MILPITAS PLANNING COMMISSION AGENDA REPORT

APPLICATION: **Preliminary Application No. PP12-0004, Warmington Homes.**

A study session to review a preliminary proposal for a 190-unit residential subdivision consisting of 32 single family homes, 158 multi-family units, and associated site improvements.

569-625 Trade Zone Boulevard (APN 86-36-003 thru 006)

Map 1:
Transit Area Sectional Land Use Plan

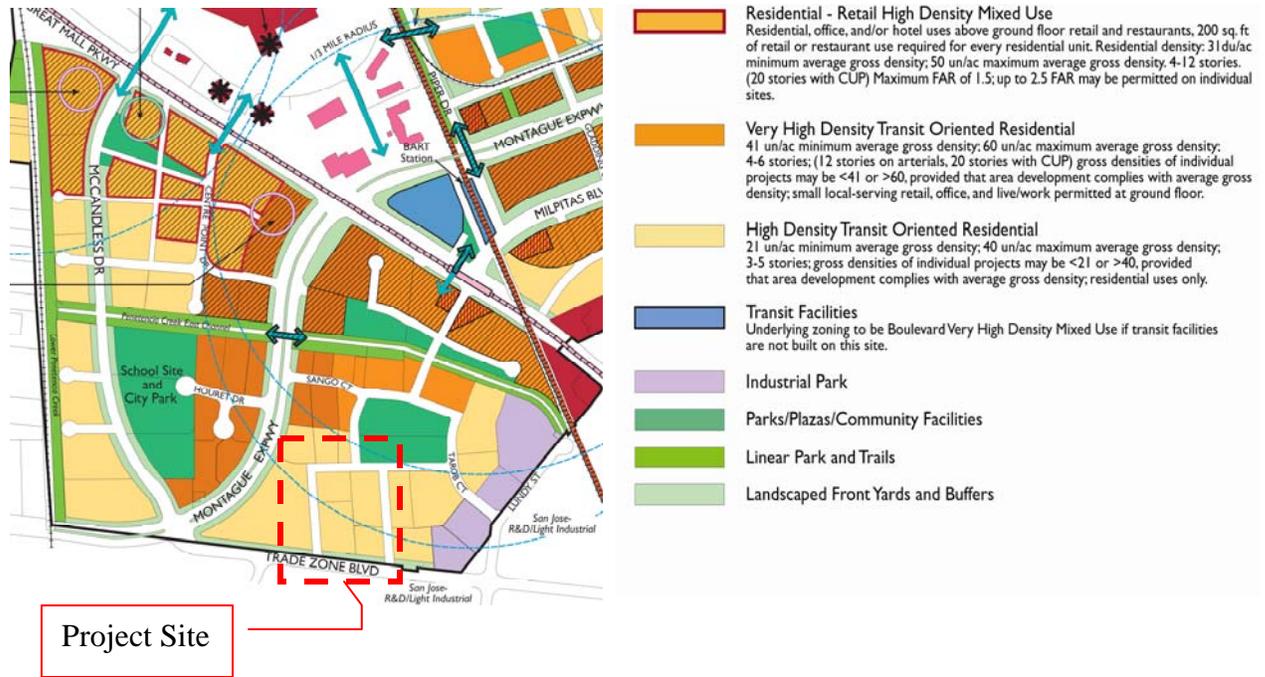
The project site is zoned and designated as Multi-Family Residential, High Density with Site and Architectural Overlay and a Transit Oriented Development Overlay which allows for a density of 21-40 dwelling units to the acre. The project site located within the Trade Zone/Montague sub district of the Milpitas Transit Specific Plan area which requires installation of new public streets and a new park site as shown in the Section TASP Land Use Map below:

Moreover, the TASP shows a second new public local street that parallels with Momentum Drive that would serve as an north-south connector between Trade Zone and the new local street and park. The project deviates from that TASP in that it proposes a "serpentine" (meandering) private street. The proposed street layout is a departure from the public through street that was anticipated for the street circulation for this sub district area. .
